CITY OF RENTON

Project Name: Sunset's Edge Townhomes		Project Number: LUA16-000864, ECF, PP, PPUD	
Date of Meeting April 11, 2017	Staff Contact Clark H. Close Senior Planner	Project Contact/Applicant Jacob Young Citizen Design Collaborative, 46 Etruria Street, Suite 201, Seattle, WA 98109	Project Location 701-707 Sunset Blvd NE, Renton, WA 98056

Sunset's Edge Townhomes (File LUA16-000864)

Preliminary Planned Urban Development and Preliminary Plat

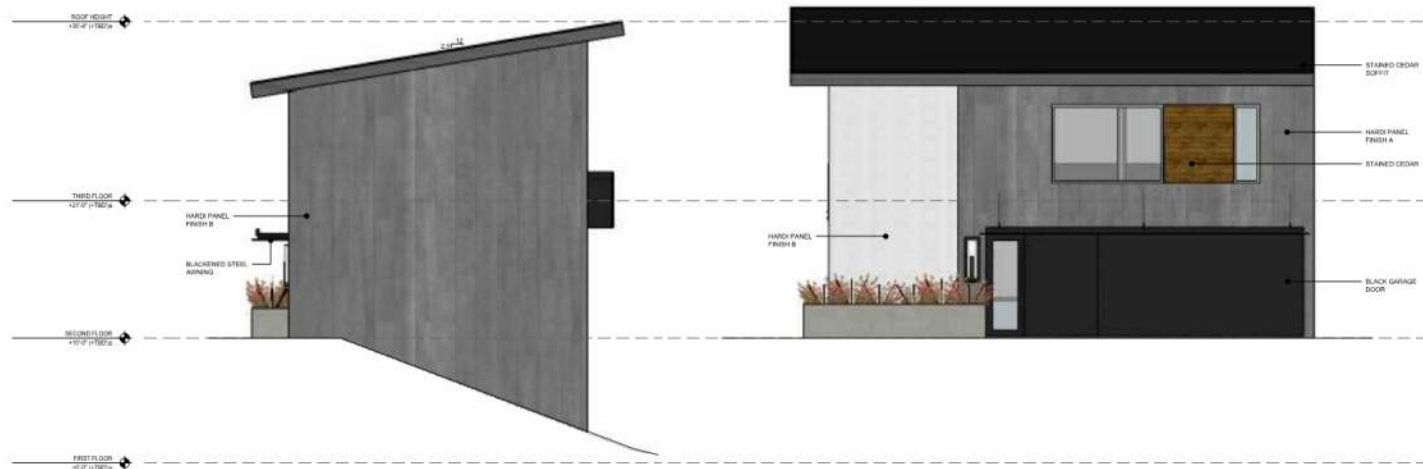
Staff would like to amend recommended condition of approval #2 that states:

2. The applicant shall submit revised elevation plans with the building permit application that verifies compliance with the 32-foot maximum wall plate height for each building. The revised elevation plans shall be reviewed and approved by the Current Planning Project Manager prior to building permit approval.

2. The applicant shall submit revised elevation plans with the building permit application that verifies compliance with the maximum wall plat height of 42 feet for each residential structure. The revised elevation plans shall be reviewed and approved by the Current Planning Project Manager prior to building permit approval.

1 UNIT TYPE D ELEVATIONS
SCALE: 1/4" = 1'-0"

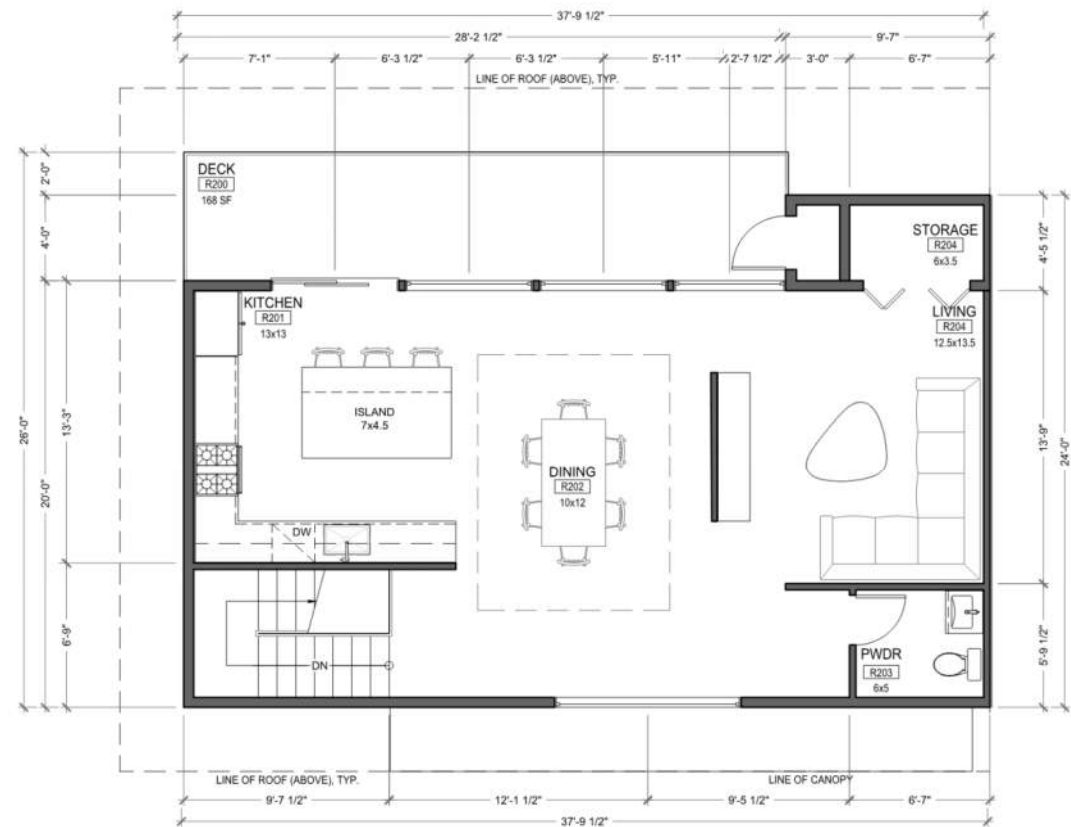
Due to the topography of the site and the necessity of providing vehicular access to the units located in the two westerly buildings, it is necessary to construct these buildings well above the existing grade at their western elevations. For example, Building 3's lowest level is approximately 13 feet above existing grade at its northwest corner. However, the grade plane calculation as described in RMC 4-11-070 requires that the grade plane be calculated based on the lowest elevations within six feet of the building's façade. In the case of these two buildings, this calculation results in a grade plane that is approximately 8.5 feet below the lowest floor level. This, in turn, causes the buildings to exceed the maximum wall plate height limit of 32 feet by approximately the same amount. Under the PUD provisions of RMC, the department may grant an additional ten feet of allowable building height to a proposed development in exchange for additional landscaped open space, recreation areas and similar features. This proposal provides 3794 sf of private open space and 5341 sf of common open space. This exceeds the required amount of private open space by 1544 sf, and no common open space would have been required outside of the PUD process. The proposal also includes a variety of recreational amenities. It appears that the requirements for the ten foot height limit bonus have been met. Therefore, we request that the bonus be granted to this project.

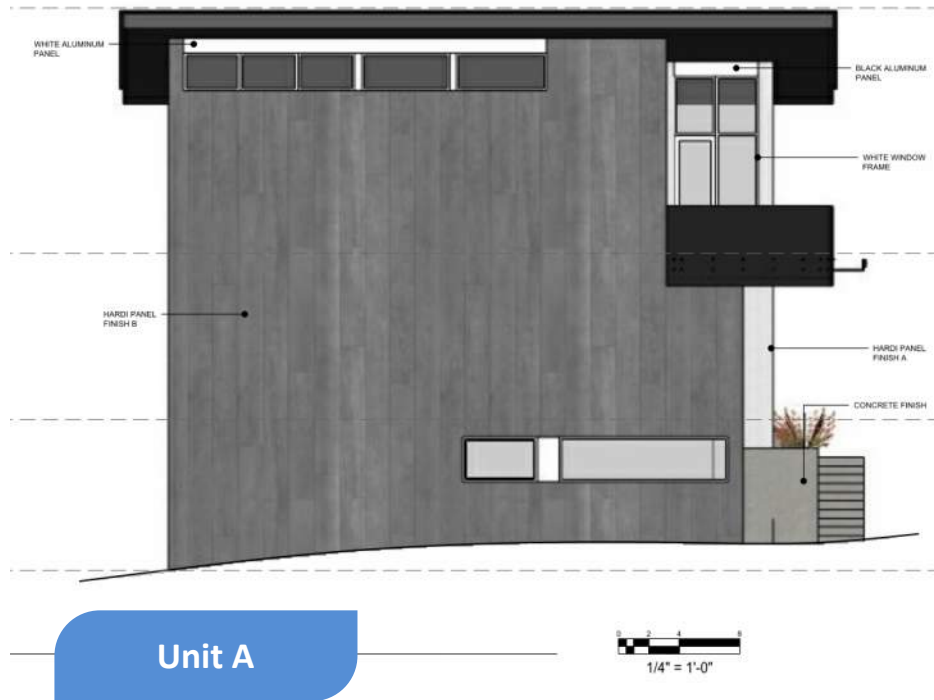
Staff would like to amend recommended condition of approval #19 that states:

19. The applicant shall submit revised elevation plans for the unattached elevations for Unit Types A and B that provide additional articulation and/or modulation that comply with the 20-foot maximum interval requirement. The revised elevation plans shall be submitted with the building permit application to be reviewed and approved by the Current Planning Project Manager prior to building permit approval.

Pursuant to the requirements of RMC 4-3-100E.5, a variety of building features may be proposed to satisfy the articulation requirement. For example, roof line features, defined entry features and bay windows are listed in the RMC as possible “articulations.” Furthermore, the RMC permits “other features as approved by the Administrator.” In order to maintain a consistent floor plan for all Type A and B units, it is preferred that the exposed side elevations of these unit types not be modulated. Therefore, we propose satisfying this requirement through the use of material changes and by provision of climbing vegetation as appropriate. It is requested that the department go on record stating that this requirement may be satisfied without the use of 2-foot modulations.

19. The applicant shall submit revised elevation plans for the unattached elevations for Unit Types A and B that provide additional material changes to satisfy the 20-foot maximum articulation and/or modulation interval requirement. The revised elevation plans shall be submitted with the building permit application to be reviewed and approved by the Current Planning Project Manager prior to building permit approval.
